July 24, 2020 | 1ST REVISION October 13, 2020 | 2ND REVISION November 4, 2020, edited December 4, 2020
Southwood ZMA 2018-003
Dear Megan :

Please accept this request for the following variations to ZMA 2018-003 Southwood Phase 1 Neighborhood Model District Code of Development. Below, you will find the provision of the code, a description of the approved standard, and the reason(s) for the requested variation.

Variations to Building Regulations Table 5 page 13

ATTACHMENT 2A: AREA AFFECTED BY REQUESTED VARIATION

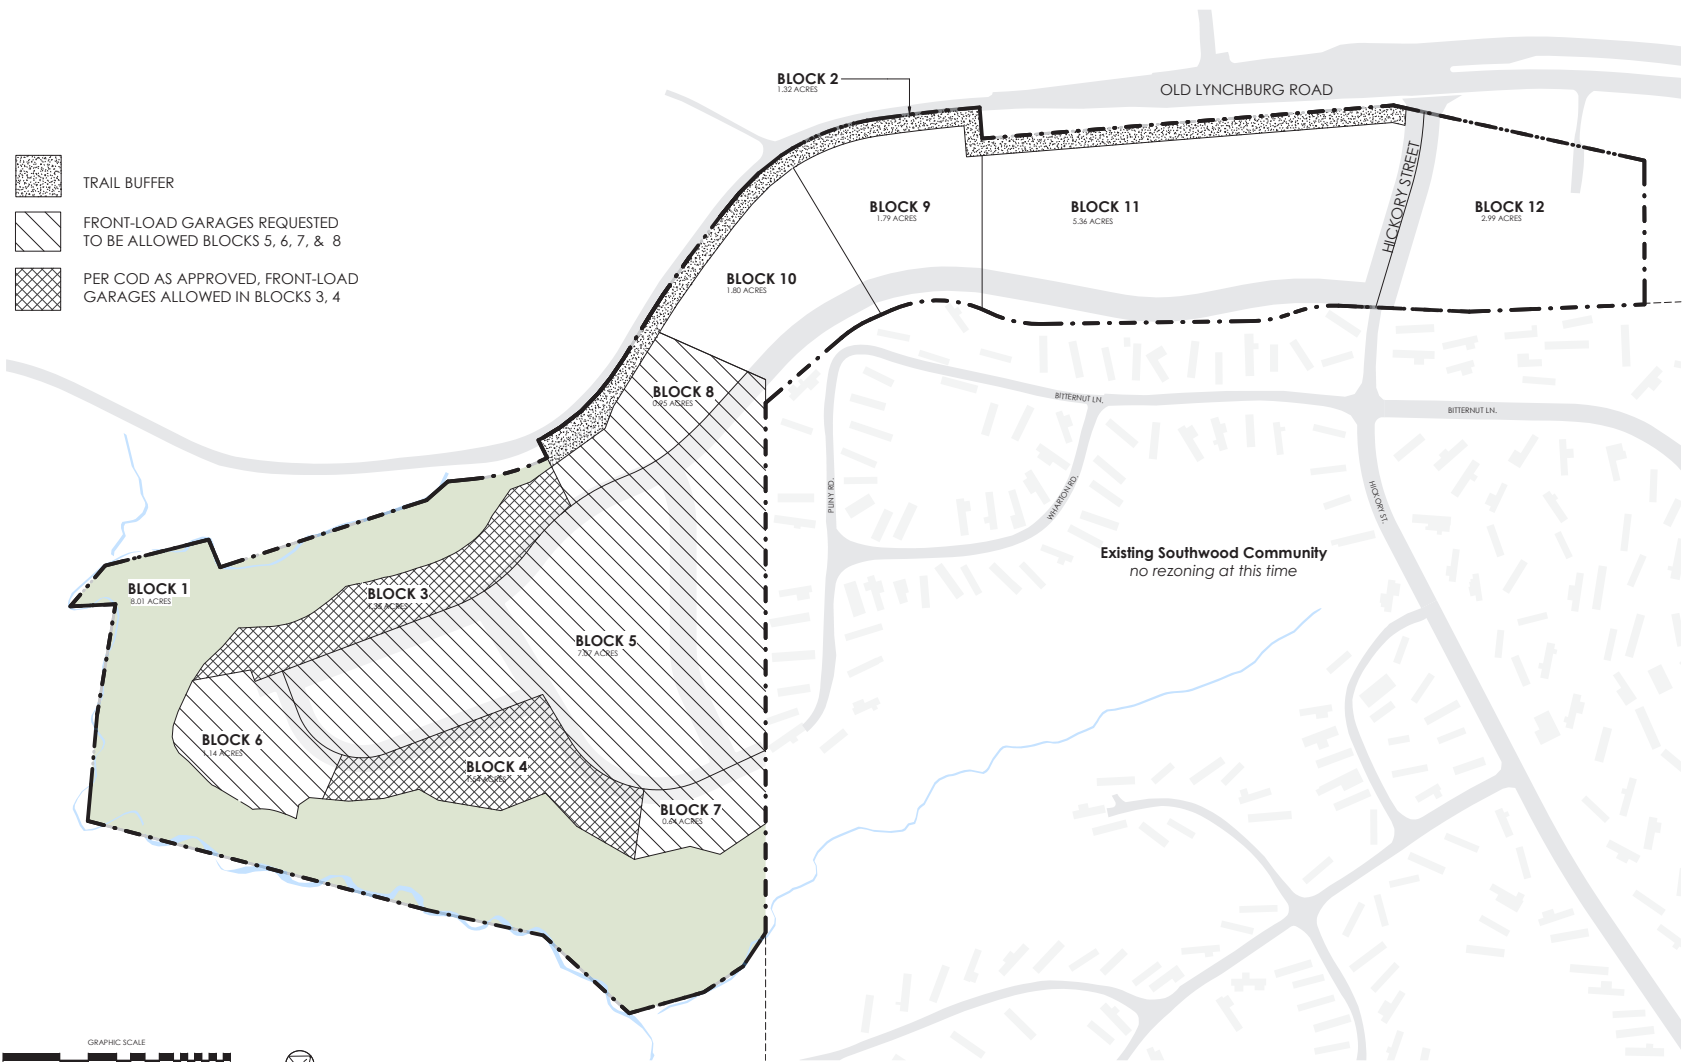
1. Garage Setback regulations in Table 5 on page 13 of Code of Development for ZMA 2018-003 Southwood Phase 1 Neighborhood Model District: As approved, the Code of Development provides Garage Setbacks from framework streets in compliance with Zoning Ordinance 4.19 in blocks 3 - 4 and does not allow framework-street-facing garages in any other block (see **attachment 1** for the original version of Table 5 as approved). This application seeks a variation to allow framework-street-facing garages in compliance with 4.19 for blocks 5 - 8 in addition to blocks 3 - 4 (see **attachments 2A** for a map of the area affected by this request). The rezoning originally intended to allow framework-street-facing garages in blocks 3 - 8 and the prohibition of front-load garages for blocks 5 - 8 was an oversight. To allow framework-street-facing, front-load garages would bring blocks 5 - 8 in alignment and equal to the adjacent blocks 3 and 4, as originally intended. Further, to allow framework-street-facing garages in blocks 5 - 8 will allow the following design goals to be fulfilled and enhanced (please see **attachment 2B** for an example of each):

- In blocks 6 - 8, lots are shallow and narrow and back to the green space, preserved slopes, and/or stream buffer of blocks 1 and 2. Front-load garages in these areas will allow units to satisfy parking requirements while providing some yard space by reducing surface parking area. Alley access, which would be required for rear-load garages in blocks 6 - 8, would be detrimental to the green space and trail buffer, again making framework street-facing, front-load garages a preferred option for these lots.

- In block 5, lots back to the recreational amenity space. A central tenant of the resident design is that residential units create a sense of protection and enclosure around the recreational amenity. Alleys and surface parking structures required to comply with a relegated parking scheme would contradict the residents' goal of providing back doors with direct access to a safe, vehicle-free play area.

ATTACHMENT 3A: AREA AFFECTED BY REQUESTED VARIATION

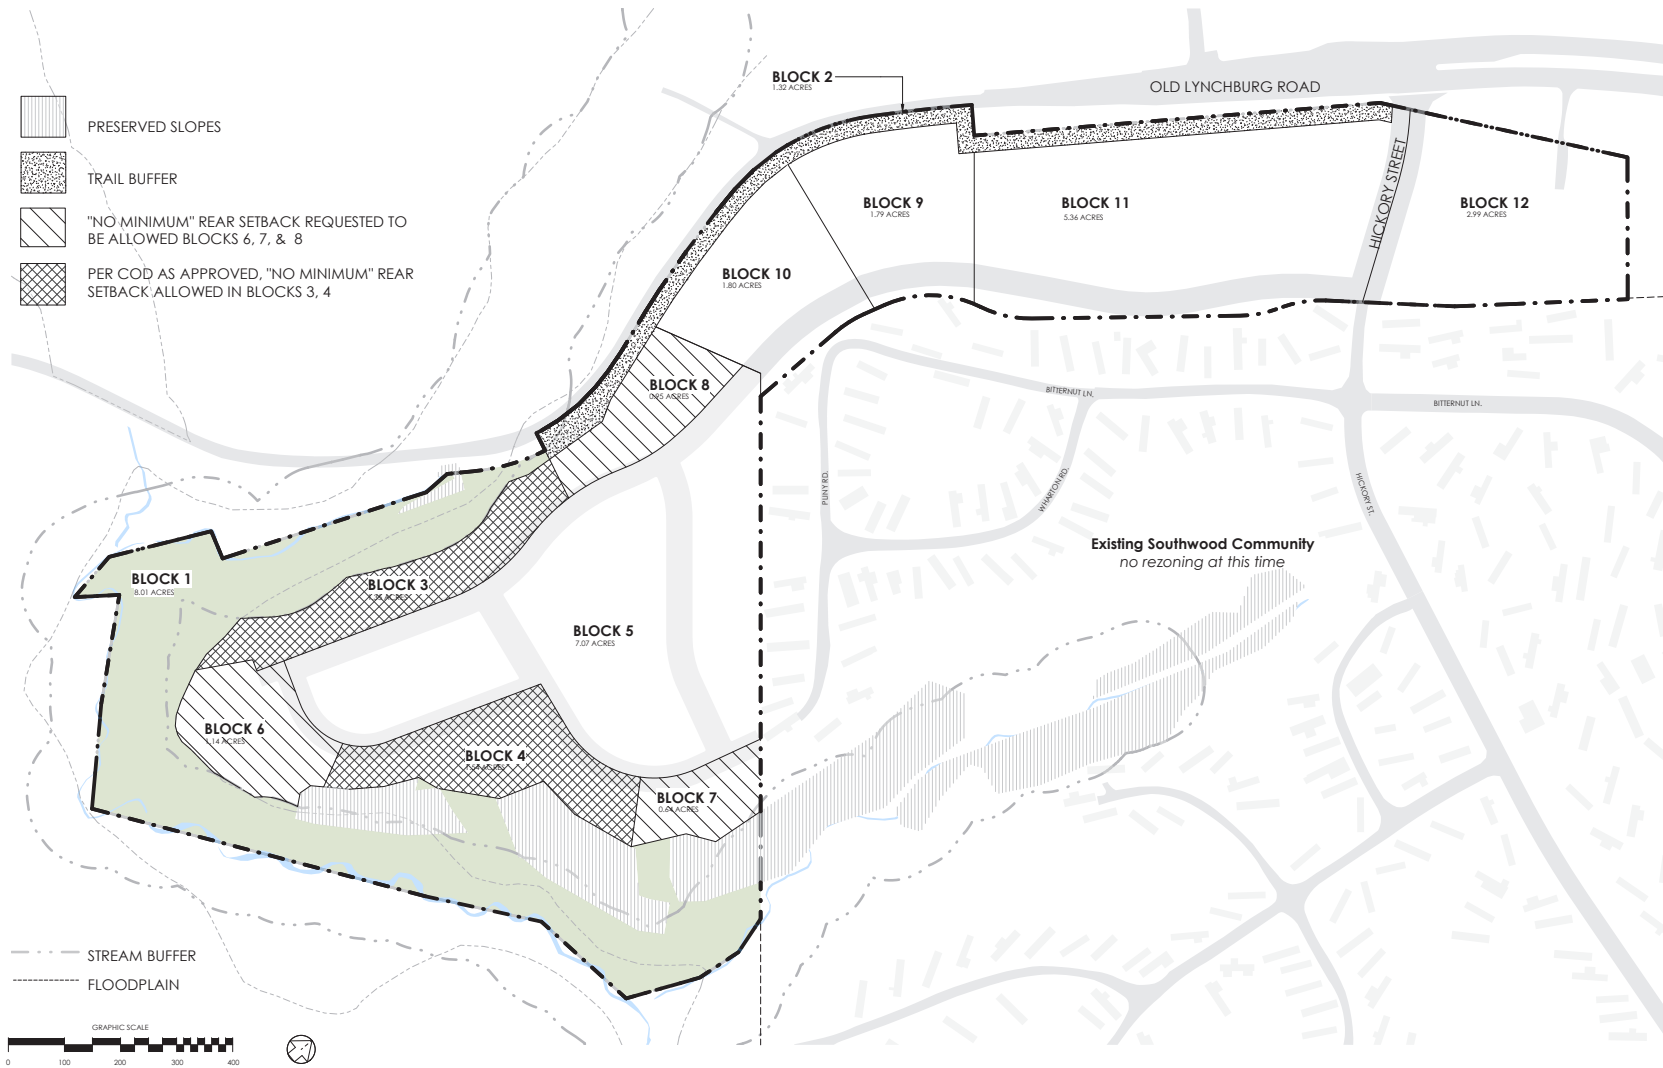
2. Rear Setbacks for Blocks 6 - 8 in Table 5 on page 13 of the Code of Development: As approved, the Code of Development provides a minimum rear setback in blocks 6 - 8 of 5 feet (see **attachment 1** for the original version of Table 5 as approved). This application seeks a variation to allow no minimum rear setback in blocks 6 - 8 (see **attachment 3A** for a map of the area affected by this request). **This will bring the rear setback for blocks 6 - 8 in alignment with adjacent blocks 3 and 4** and will allow the opportunity to maximize buildable area in lots that typically backup to the stream buffer, flood plain, or preserved slopes. As lots are not allowed within the stream buffer, flood plain, or preserved slopes, these areas will be protected **and any grading within a residential lot will not be allowed to disturb these environmental features.** Please see **attachment 3B** for an example of lots and proposed setback request for blocks 6 - 8.
